367. Tivoli Orbitor - Passenger Containment

Safety Bulletin

Bulletin No: RMSA003

Ride Type: RE-MIX 6 arm / Re-Mix II 4arm
(aka. Extreme, Techno Power)

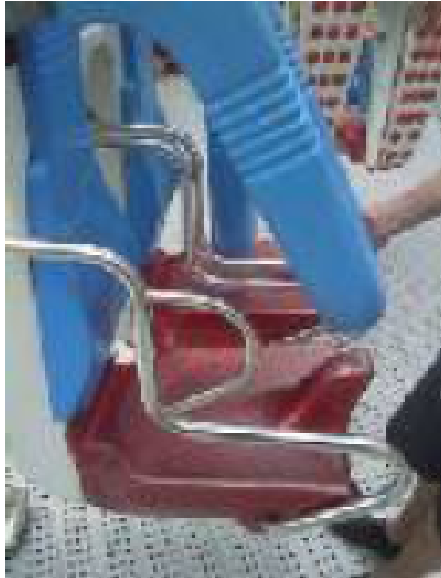
Purpose: Additional Side bar installation

An incident recently occurred where a passenger exited the ride seat on a ReMix II while it was in motion. At this time the incident is still under investigation. Although no similar incident has ever occurred in the United States since the initial delivery of this type of ride in 1999, Tivoli has elected to install an additional side bar on all types of ReMix Rides. This additional bar is shown in the photos below, and must be installed on all types of Remix rides as soon as possible.

These side bar additions are to be welded into position On the outside bars either using TIG or MIG welding procedures. Welding should be completed by a certified welding technician with experience in welding stainless steel. All welds are to be cleaned and polished, removing all sharp edges when completed.
